The Executive Committee  
Strata Plan 51487  
Victoria Tower  
197 Castlereagh Street  
Sydney NSW 2000

1 May 2017

**DA/2017/349 – SUBMISSION FOR STATE SIGNIFICANT DEVELOPMENT APPLICATION FOR STAGE 1 CONCEPT APPROVAL FOR THE CONSTRUCTION AND USE OF A 50 STOREY (RL198.22) MIXED USE BUILDING**

**Figure 5.6**  
Where sites have three street frontages smaller setbacks may be acceptable on both minor pedestrian streets provided an average weighted setback of at least 8m is maintained to north-south streets and major pedestrian streets

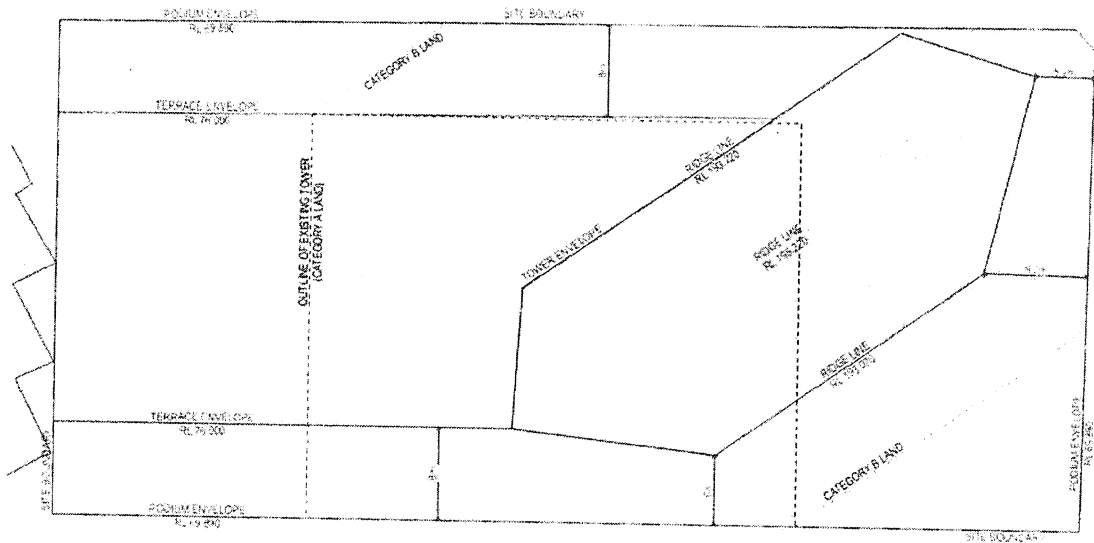
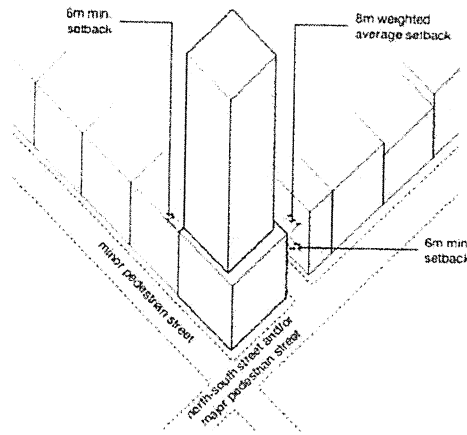
According to Sydney DCP 2012 Clause 5.1.2 Building Setbacks and Figure 5.6; there should be a minimum average setback of 8m above the required podium level on the main pedestrian north-south street (assuming it's Elizabeth St) and a minimum setback of 6m on the secondary streets. Appendix

B Building Envelope – Roof Plan prepared by FJMT show that's these principles do not comply. The tower component encroaches on all 3 sides of the streets. The worst being Castlereagh Street where the proposed tower raises 50 storeys with zero setback.

- (1) Buildings must be set back a minimum weighted average of 8m above the required street frontage height. This setback may be reduced in part by up to 2m provided that the weighted average setback from the street frontage alignment is 8m as shown in Figures 5.4 to 5.6. No part of the building is to be setback less than 6m.
- (2) The weighted average setback may be reduced on secondary or minor pedestrian streets, provided that an average weighted setback of at least 8m is maintained on north-south streets and major pedestrian streets.
- (3) New buildings or additions above a heritage item must have a setback of at least 10m from the street frontage as shown in Figure 5.7 *Minimum setback above a heritage item*. However, a conservation management plan required as part of the development application may require a greater setback.
